SERVICE INFORMATION NO. SI-42-122

GARMIN Service Bulletin No. 0823 Revision C
ATA-Code: 34-00

**** MANDATORY ****
SERVICE BULLETIN
NO.: 0823 Rev C

SUBJECT: GDU 104X CRS/BARO Knob Interference

Figure 1

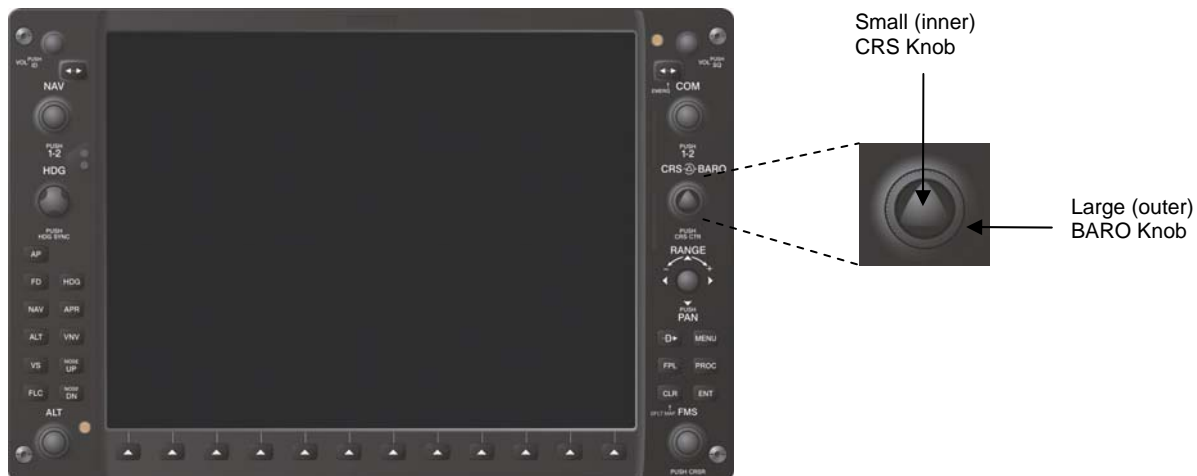
Garmin has identified an issue, whereby the large (outer) BARO knob and the small (inner) CRS knob may interfere with each other.

1. Apply power to the G1000/G900X/G950.
2. Press the CDI softkey on the Primary Flight Display(s) (PFD) to enter VOR mode on the HSI.
3. Rotate the large (outer) BARO knob (refer to Figure 1) a minimum of three complete revolutions in each direction while monitoring the Horizontal Situation Indicator/Digital Course Indicator (refer to Figure 3) on the PFD. If a change in the Horizontal Situation Indicator/Digital Course Indicator is produced while turning the BARO knob proceed to the Modification Instructions.

4. Rotate the small (inner) CRS knob (refer to Figure 1) a minimum of three complete revolutions in each direction while monitoring the Barometric Altimeter Setting (refer to Figure 3) on the PFD. If a change in the Barometric Altimeter Setting is produced while turning the CRS knob proceed to the Modification Instructions.
5. Repeat Steps 3 and 4 for each affected GDU.

If CRS/BARO Knob interference is confirmed, perform the steps below to replace the CRS/BARO Knob. New knobs can be obtained through a Garmin Service Center or Aircraft OEM under Garmin part number K00-00446-00.

1. Grasp the small (inner) CRS knob and firmly pull the knob off the shaft.
2. Discard knob.
3. Grasp the large (outer) BARO knob and firmly pull the knob off the shaft.
4. Discard knob.

Figure 4

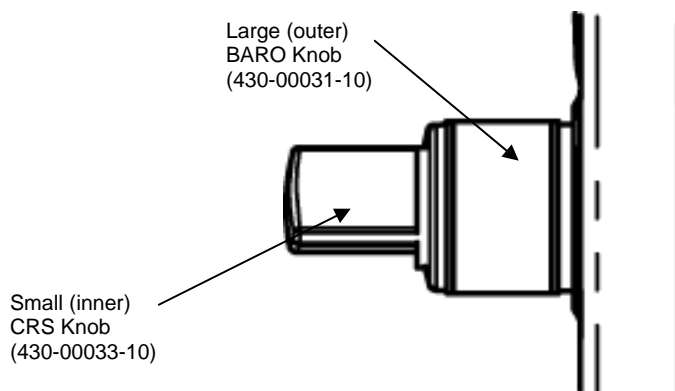
5. Grasp the large (outer) BARO knob (insuring proper orientation) and place it over the shaft.
6. Align the flat side of the knob insert with the flat side of the shaft.
7. Press down firmly to ensure knob is completely seated, refer to Figure 4.
8. Grasp the small (inner) CRS knob (insuring proper orientation) and place it over the shaft.
9. Align the flat side of the knob insert with the flat side of the shaft.
10. Press down firmly to ensure knob is completely seated, refer to Figure 4.
11. Perform the CRS/BARO Knob Interference Test (contained in the TESTING PROCEDURE section) again to confirm there is no interference.
12. Accomplish aircraft logbook entry to return aircraft to service in compliance with this service bulletin.
